# CITY OF MUSKEGON

## HISTORIC DISTRICT COMMISSION

**November 4, 2025 @ 4:00 PM**

1/4" = 1'-0"

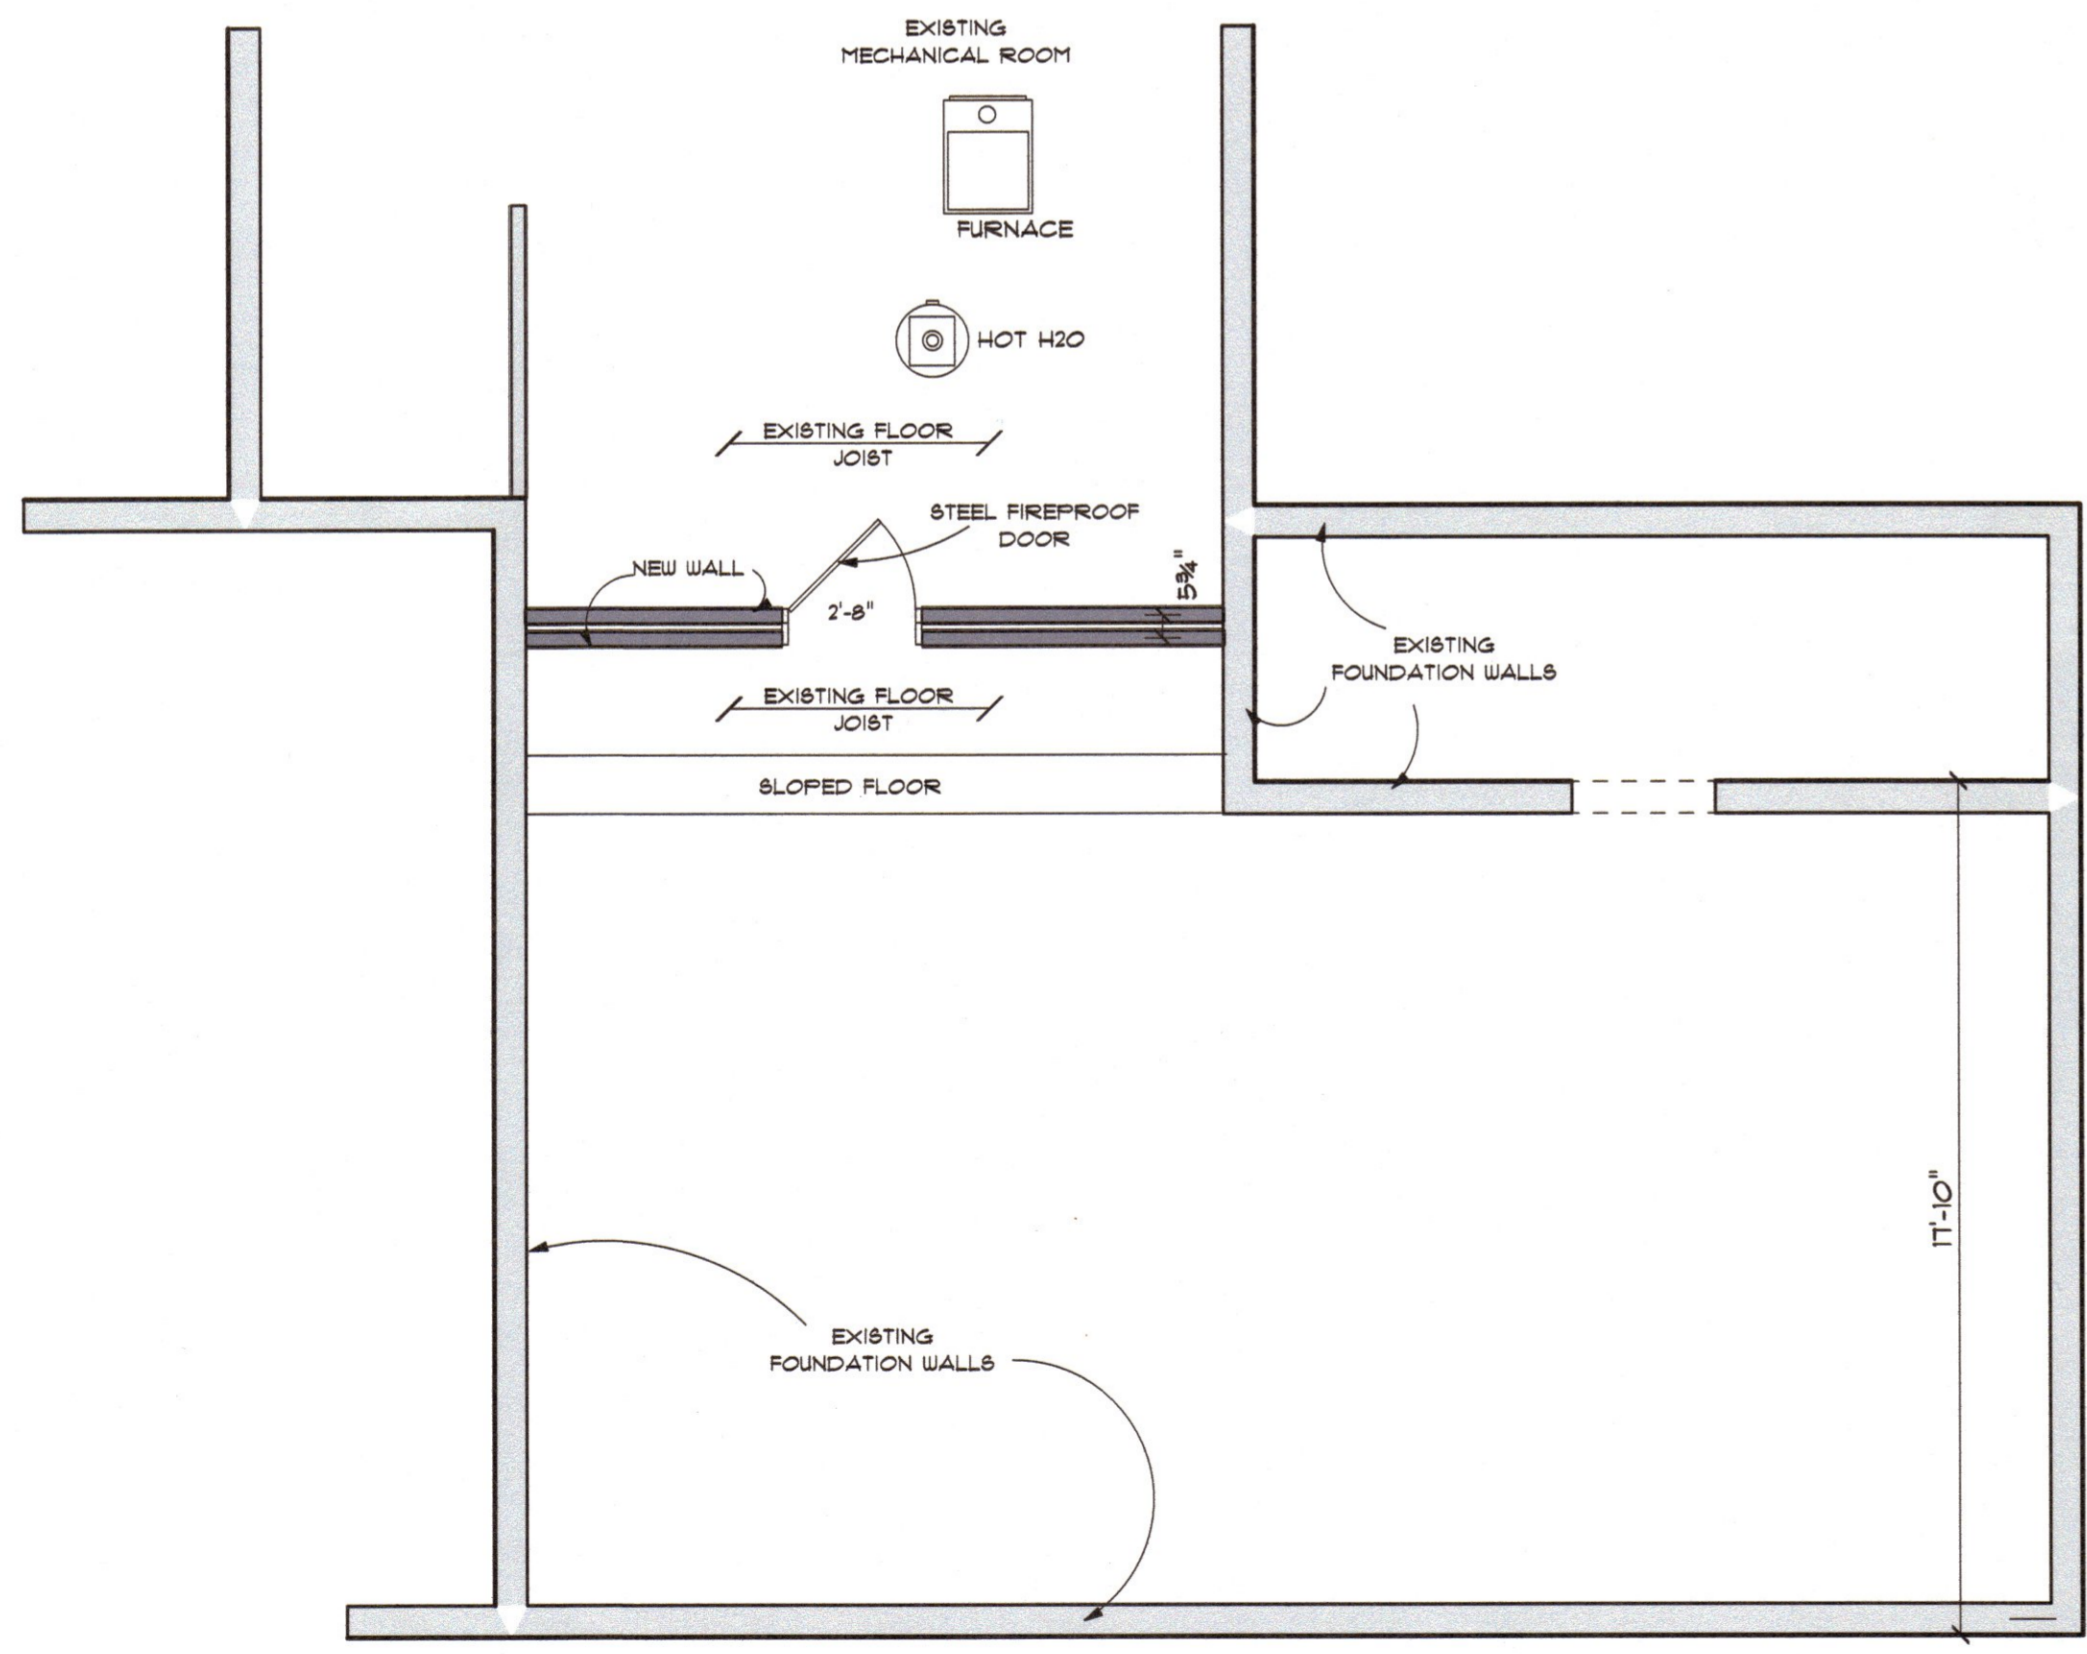
<b>Case 2025-30: 390 W. Muskegon</b>	<b>Description of Work:</b> Windows and Gutters
<b>Applicant:</b> Lusk Properties	<b>District:</b> Houston
<b>Current Use:</b> Residential	<b>Date of Construction:</b> 1/1/1890
<p><b>Discussion:</b></p> <p>The applicant is seeking approval to replace the windows in the house (excluding the garage windows) with single-hung vinyl windows of the same size and appearance including a vertical mullion within each pane, remove two windows on the east (side) elevation and two windows on the north (rear) elevation and side over the existing openings to match the rest of the house, install a smaller, 30"x36" vinyl replacement window within an existing window opening on the north elevation and side over the remaining lower portion of the rough opening to match the rest of the house, and install gutters on the eaves on portions of the east and north elevations.</p>	
<p><b>Standards:</b></p> <p>See attached <i>Window, Door, and Exterior Woodwork Standards and Guidelines</i> in Case 2025-29, above.</p>

<p><b>Deliberation:</b></p> <p>I move that the HDC (approve/deny) the request to replace the windows in the house (excluding the garage windows) with single-hung vinyl windows of the same size and appearance including a vertical mullion within each pane, remove two windows on the east (side) elevation and two windows on the north (rear) elevation as identified in the November 4, 2025 HDC Staff Report and side over the existing openings to match the rest of the house, install a smaller, 30"x36" vinyl replacement window within an existing window opening on the north elevation as identified in the November 4, 2025 HDC Staff Report and side over the remaining lower portion of the rough opening to match the rest of the house, and install gutters on the eaves on portions of the east and north elevation as long as the work meets all zoning requirements and the necessary permits are obtained.</p>
